COMANCHE PEAK STEAM ELECTRIC STATION  
UNITS NOS. 1 AND 2

PROTECTIVE COATINGS  
SPECIFICATION 2323-AS-31  
APRIL-45, -1977-  
REVISION 1 - MARCH 15, 1978

THIS DOCUMENT IS AFFECTED  
BY THE FOLLOWING APPROVED  
DESIGN CHANGES)

TYP PIPE SUPPORT  
ELEVATION VIEW

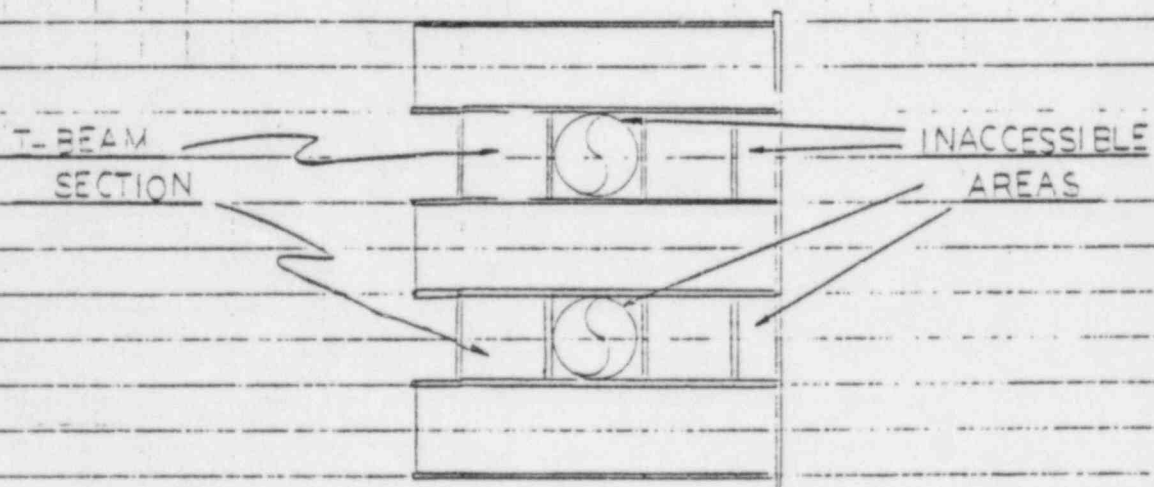
DCA 7805

# POLAR CRANE GIRDER BRACKET

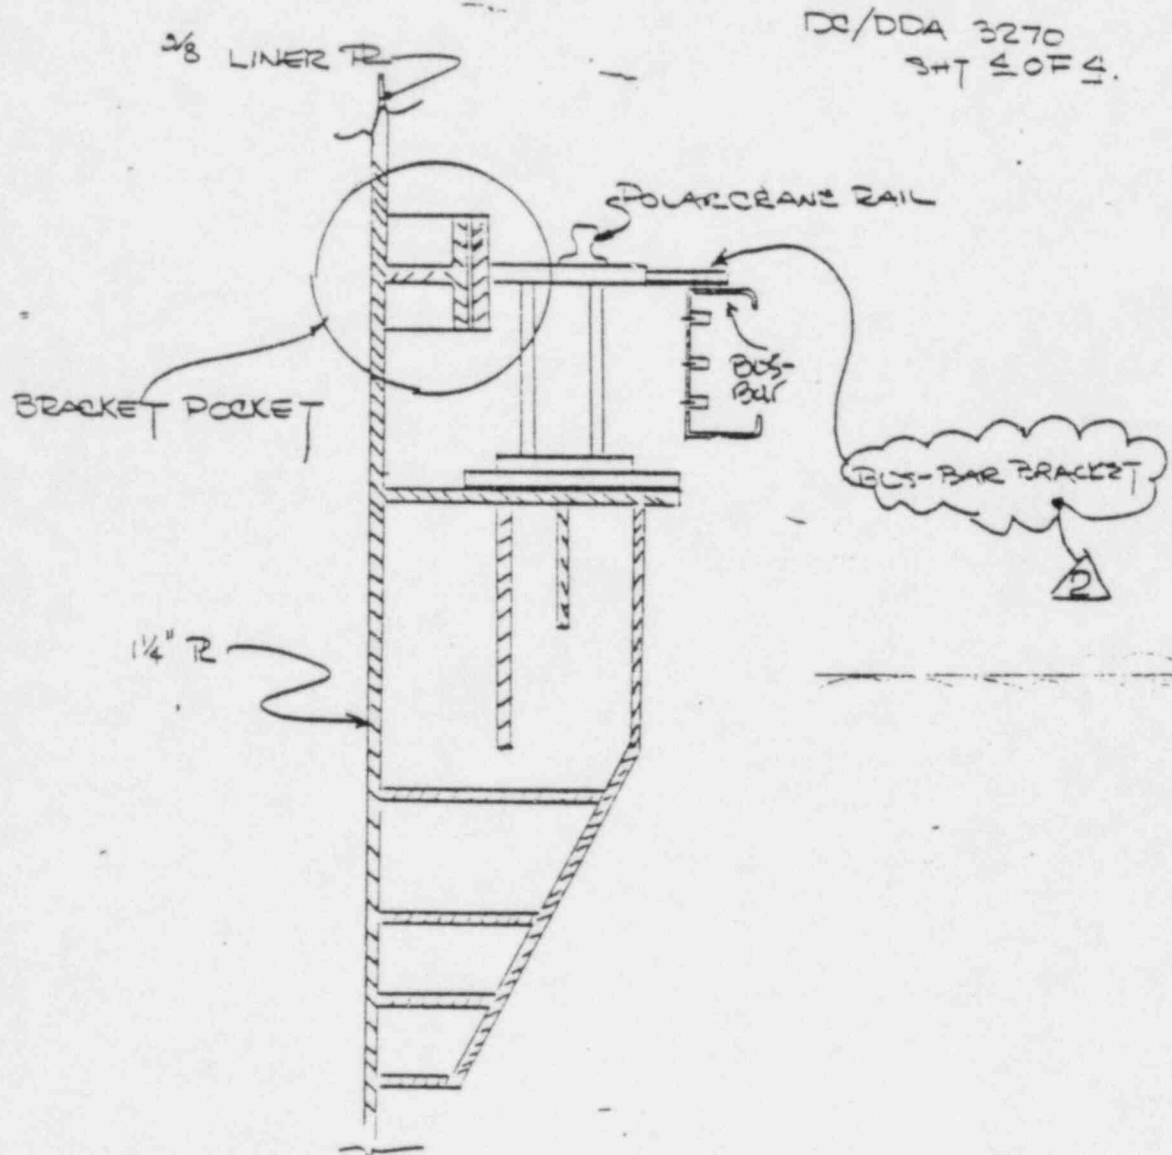
B. DETAILS Request authorization to delete inspection of surface preparation on hand worked weld areas in Containment 1 and 2 elevation 950'-7" to 947'-7", Azimuth 0° - 360°. Inspection shall be deleted for the areas located behind the Polar Crane bus-bar along with the bus-bar bracket.

The design change (DCA-3270-REV.2) shall not alter the disposition of NCR C-677 issued on 7-1-77.

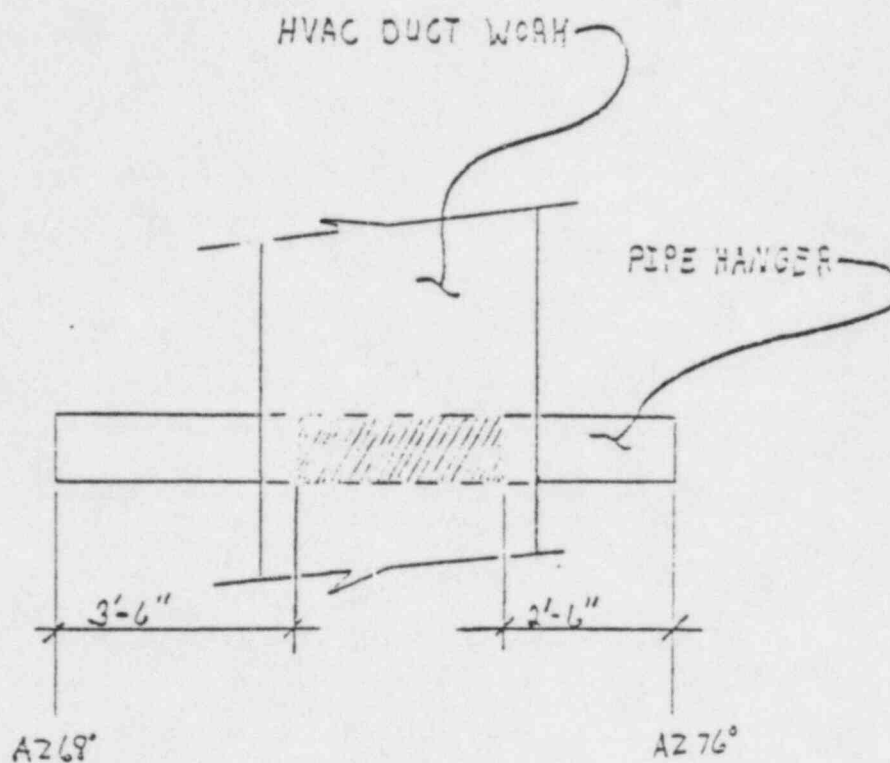
Sol: The inaccessible areas, shown as shaded areas on attached drawing, shall be removed from AS-31 coating and Inspection requirements and coated on a best effort basis. All remaining portions shall be coated under full AS-31 requirements.

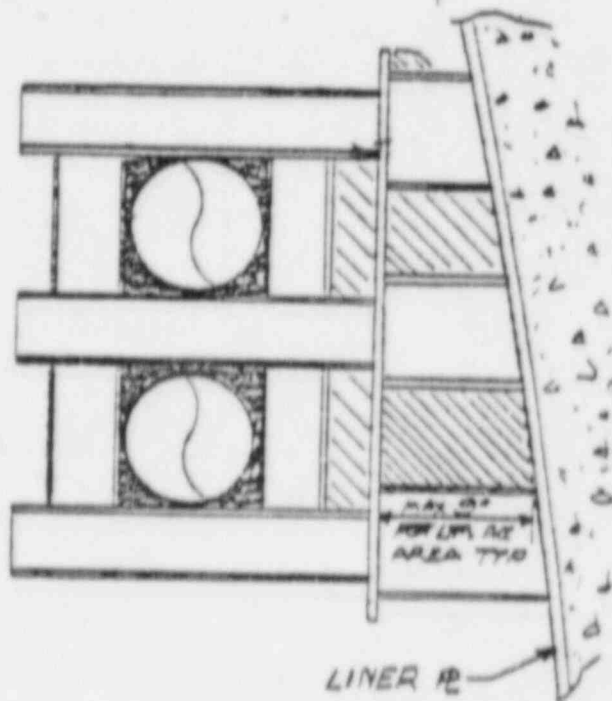
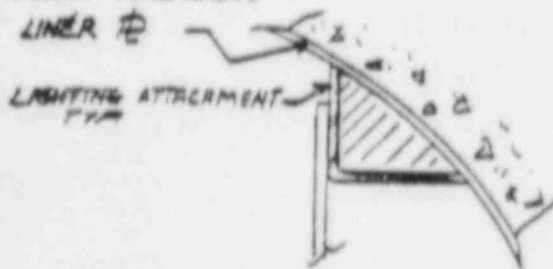
1. LIMITED ACCESS AREAS SHOWN ARE DESIGNATED BY HATCHED AREAS.

2. LIMITED ACCESS SHOWN ARE TYPICALS; OTHER SIMILAR CONFIGURATIONS MAY ALSO BE LIMITED ACCESS.

3. SHADED AREAS REPRESENT WALKABLE AREAS & SHALL BE PREPARED & COATED ON A BEST EFFORT BASIS.
